Groundwater Application Review Summary Form

Application # G- 18392

GW Reviewer Gerald H. Grondin

SUBJECT: Application G-18392 Supersedes review of _____
Date of Review(s)

LAKE 52274 to Crooked Creek

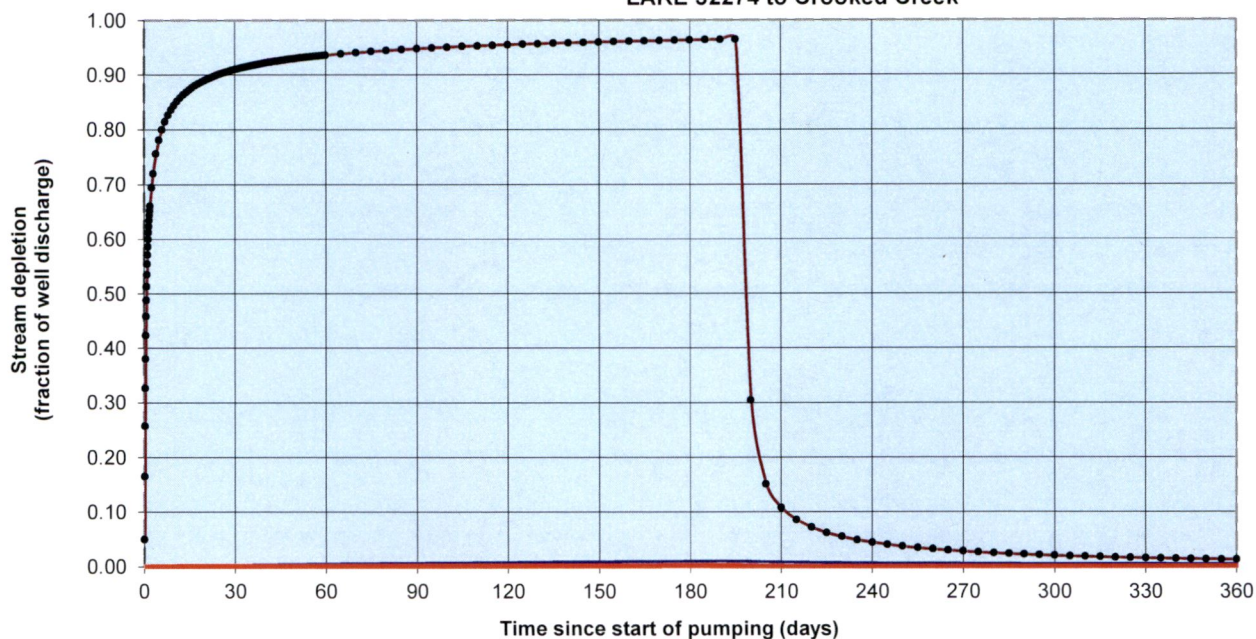
Hunt (2003) was used to calculate the groundwater pumping interference with Crooked Creek. The calculation used a transmissivity of 2,490 ft²/day derived from specific capacity data for nearby well LAKE 1769, an intermediate storage coefficient of 0.001, a 0.0498 ft/day vertical hydraulic conductivity for the basin fill (horizontal conductivity divided by 100), and a pro-rated pumping rate of 1.22 cfs (548 gpm) derived by dividing the proposed maximum annual volume (480.12 ac-ft) by the proposed total days of pumping (198 days).

Under OAR 690-009, a potential for substantial interference is automatically found given: available data indicating Crooked Creek is a perennial creek; groundwater in the area is unconfined and hydraulically connected to surface water; the proposed POA well is less than 1-mile from Crooked Creek; and the proposed maximum pumping rate is greater than one-percent of the natural flow (80% exceedance).
